R44 SERVICE BULLETIN SB-83

SUBJECT: Tail Rotor Blade Fatigue Cracks

ROTORCRAFT AFFECTED: R44 and R44 II helicopters with P/N C029-1 or C029-2 tail rotor blades installed.

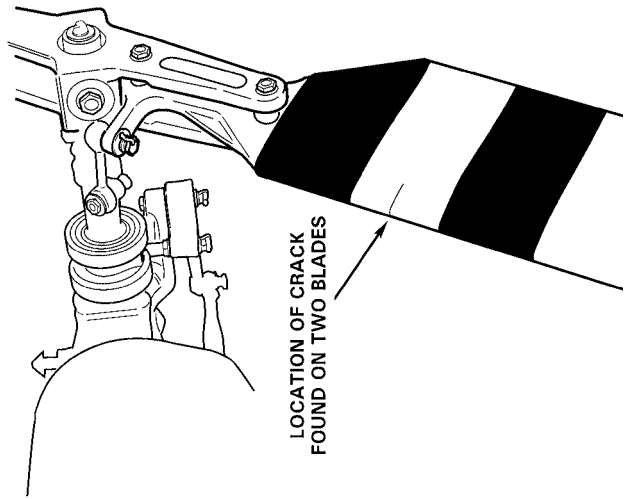
Cracks have been found in C029-2 tail rotor blades at the leading edge in the most inboard white paint stripe (see figure). The cracks were found by pilots during preflight checks. Cracks are caused by high fatigue stresses during maneuvers with large left pedal inputs. C029-1 blades have the same construction and therefore would also be susceptible to cracking.

Prior to each flight, inspect leading edges of tail rotor blades for cracks. Wipe blades clean if necessary to make sure potential cracks are visible.

To reduce fatigue stress damage to the blades, avoid maneuvers which require large left pedal inputs.
